NORTHEAST TRANSMISSION DEVELOPMENT

June 7, 2016

RE: PJM 2016/17 Input Assumptions (Market Efficiency)

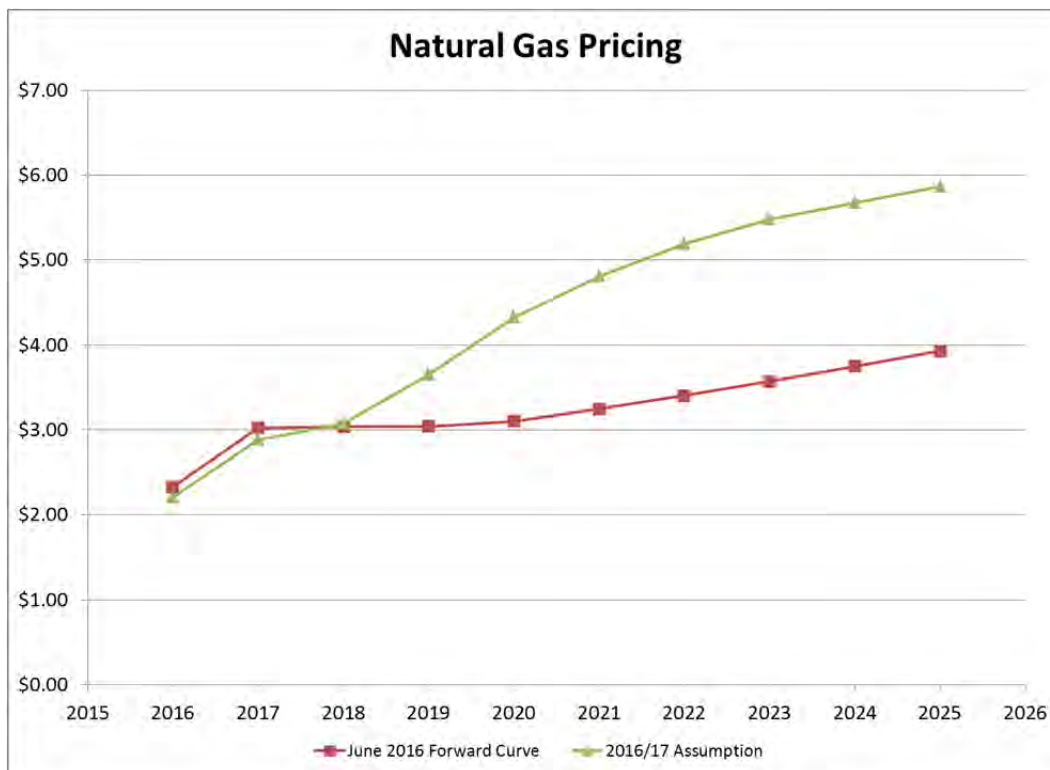
The proposed fuel price assumptions appear to be inconsistent with current market forward pricing as shown in the figure below. It is unclear the basis for PJM's proposed assumptions to cause 40-50% higher natural gas costs in 2020 and beyond as compared to current forward pricing. Unrealistic fuel price assumptions could significantly impact economic transmission planning.
